Outstanding issues in Clause 36, 48 and 49 state diagrams

Velu Pillai
IEEE 802.3az, Chicago, Sept 2009

Figure 49-17—LPI Receive state diagram

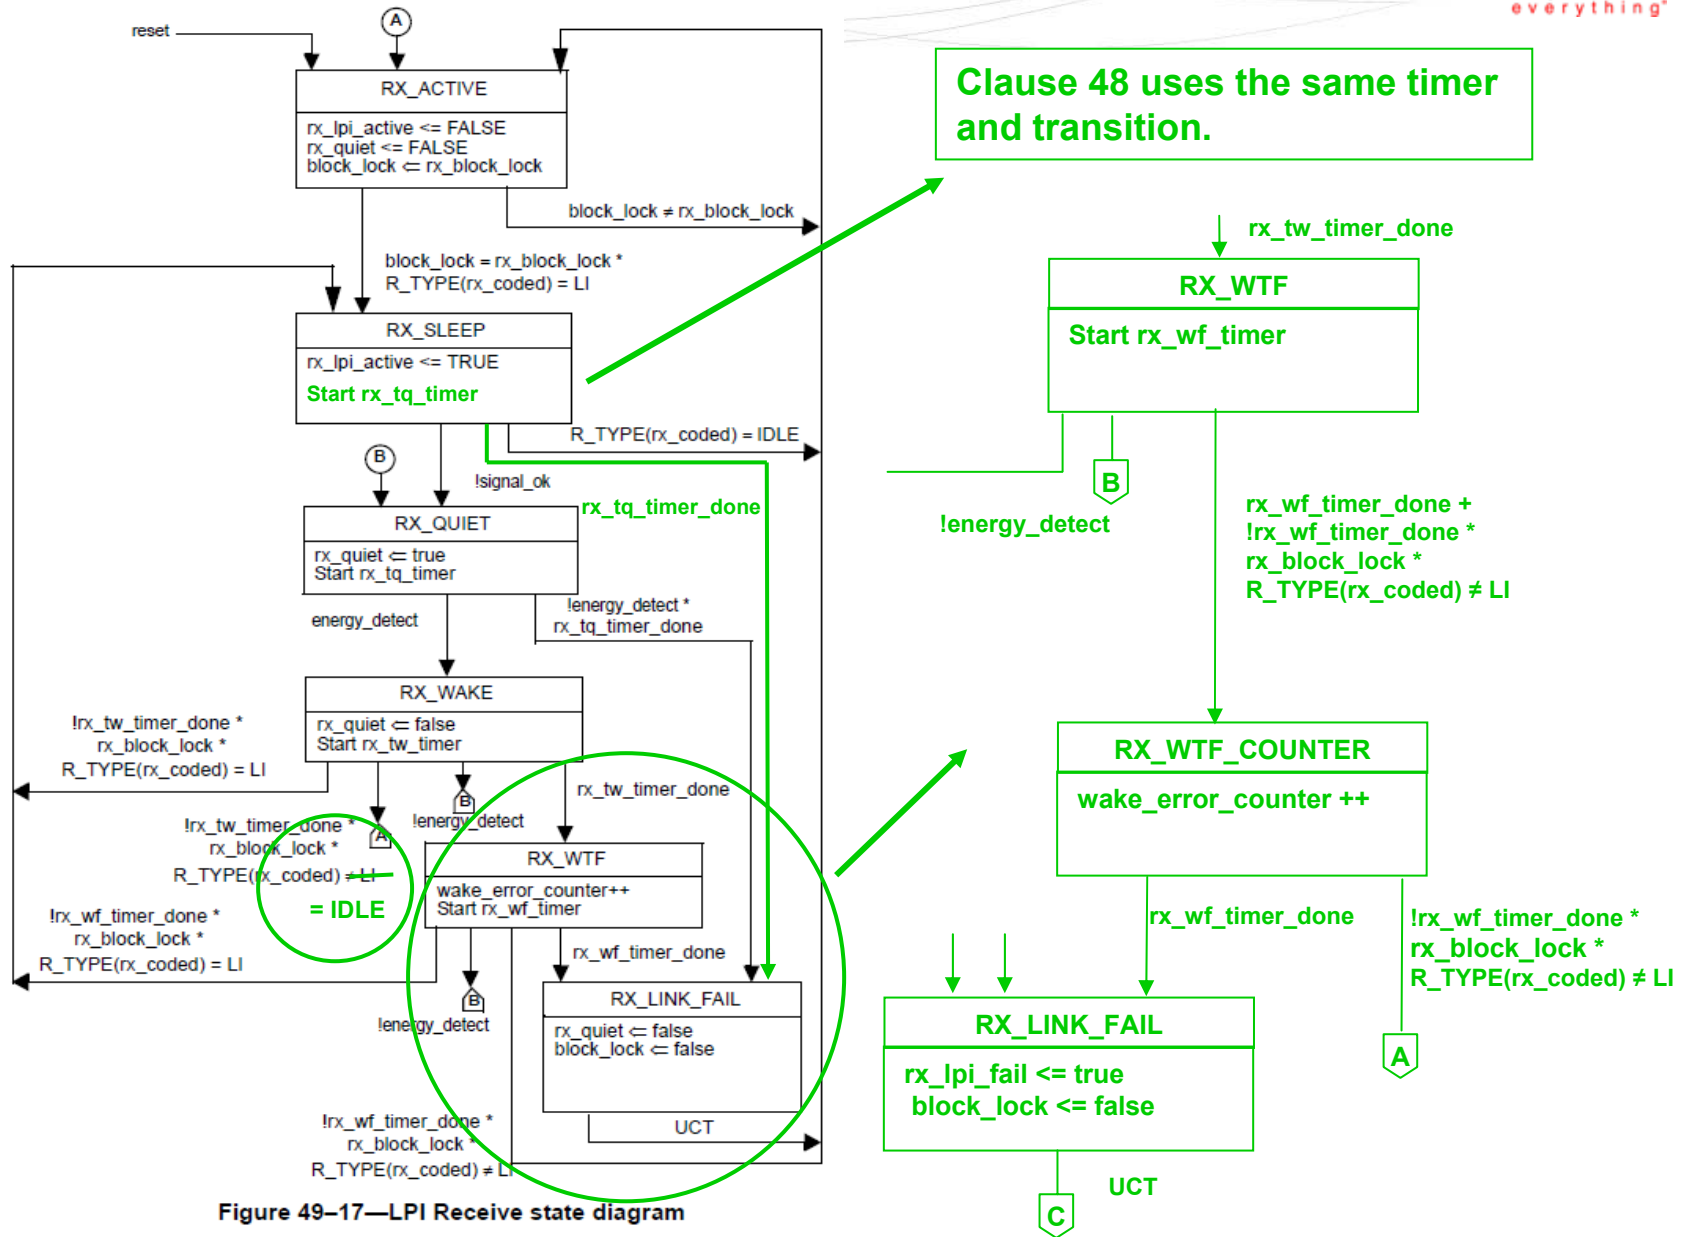
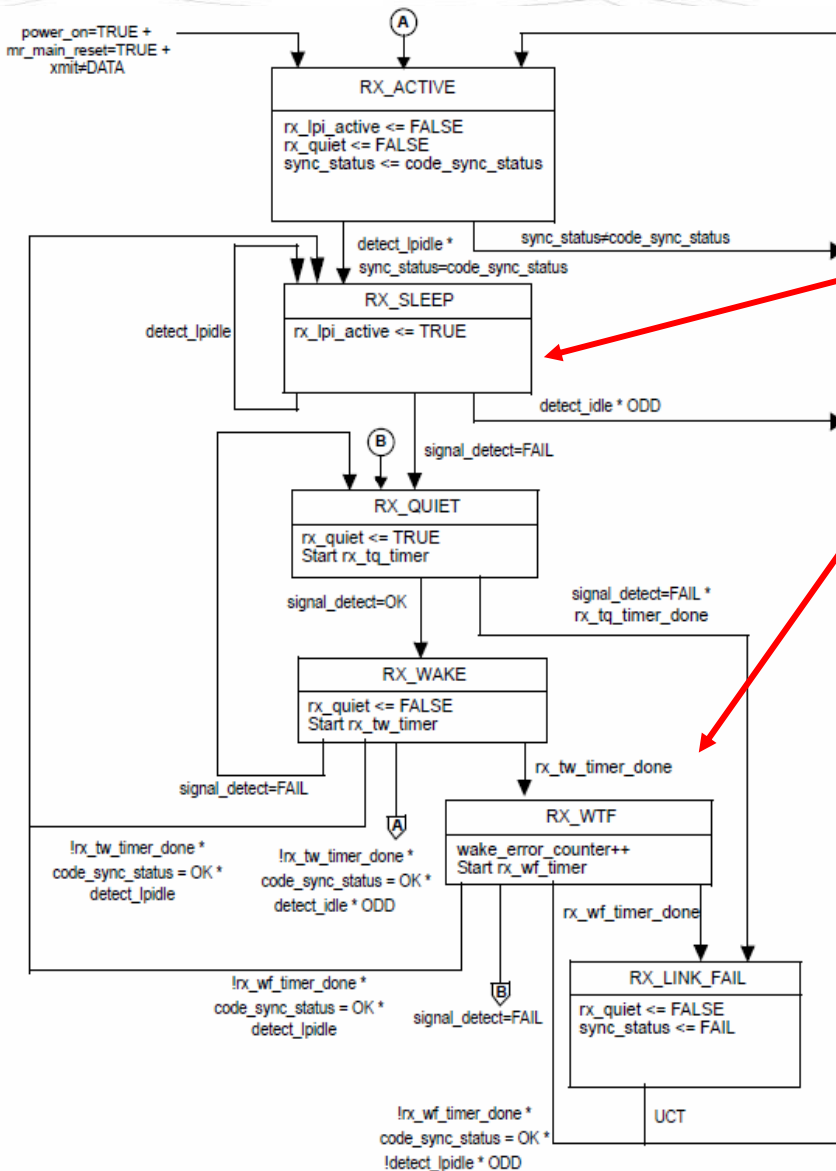
Issue #1: When the Receiver is in this state, if the LP restarts and starts transmitting DME pages, then the receiver will be stuck in this state.

Issue #2: rx_tw_timer_done = T_{UL} = 17uSec fails in 3 cases.

The receiver will not achieve rx_block_lock during a refresh cycle when FEC is enabled.

- If the transmitter starts waking up during a refresh, the above timer will expire and the receiver will enter RX_WTF. Which means the wake_error_counter will be incremented. This is an issue.
- Even during a normal refresh cycle the timer expires before the energy detect goes away, which will also cause the receiver to enter RX_WTF and increment the error counter.

These two cases unnecessarily increments the error counter, which will make the count value inaccurate.

3 If this counter is incremented due to the above two cases, then a receiver compliancy test will be inaccurate.

Issue #3: These should be R_TYPE(rx_coded) = IDLE

Suggested solutions

Figure 36-9b—LPI Receive state diagram

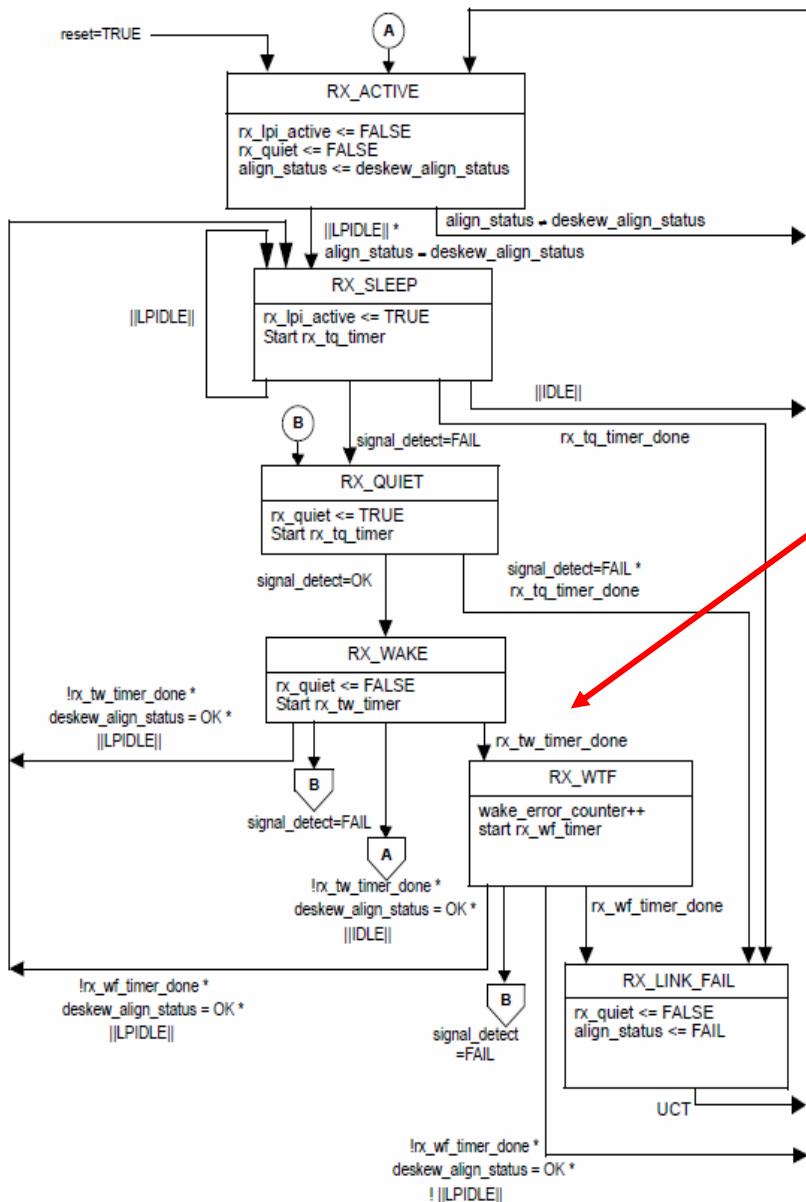
Issue #1: When the Receiver is in this state, if the LP restarts and starts transmitting Auto negotiation, then the receiver will be stuck in this state.

Issue #2: If the transmitter starts waking up during a refresh, the above timer will expire and the receiver will enter RX_WTF. Which means the wake_error_counter will be incremented. This will make the count value inaccurate. If this counter is incremented due to the above case, then a receiver compliancy test will be inaccurate too.

Suggested solution for #1
Same as Clause 48 and Clause 49 LPI receiver state diagram. Use rx_tq_timer to exit out of RX_SLEEP to RX_LINK_FAIL.

Suggested solution for #2
Same as Clause 48 and Clause 49 LPI receiver state diagram. Insert a new state RX_WTF_COUNTER and move the wake_error_counter increment to this new state.

Figure 48-9b—LPI Receive state diagram

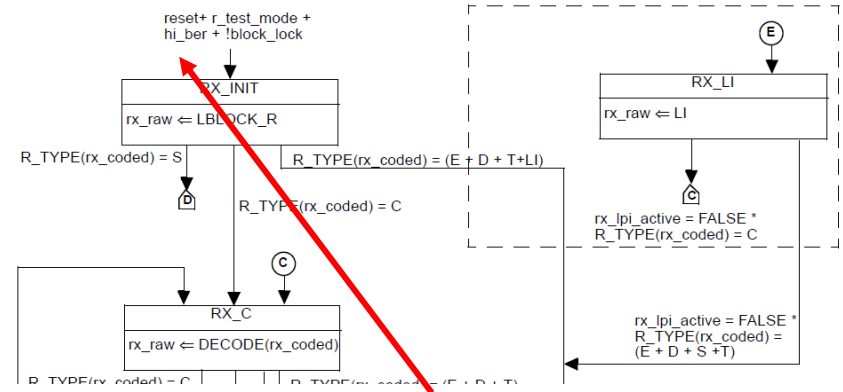
Issue #1:
 If the transmitter starts waking up during a refresh, the above timer will expire and the receiver will enter RX_WTF. Which means the wake_error_counter will be incremented. This will make the count value inaccurate.
 If this counter is incremented due to the above case, then a receiver compliancy test will be inaccurate too.

Suggested solution for #1
 Same as Clause 36 and Clause 49 LPI receiver state diagram. Insert a new state RX_WTF_COUNTER and move the wake_error_counter increment to this new state.
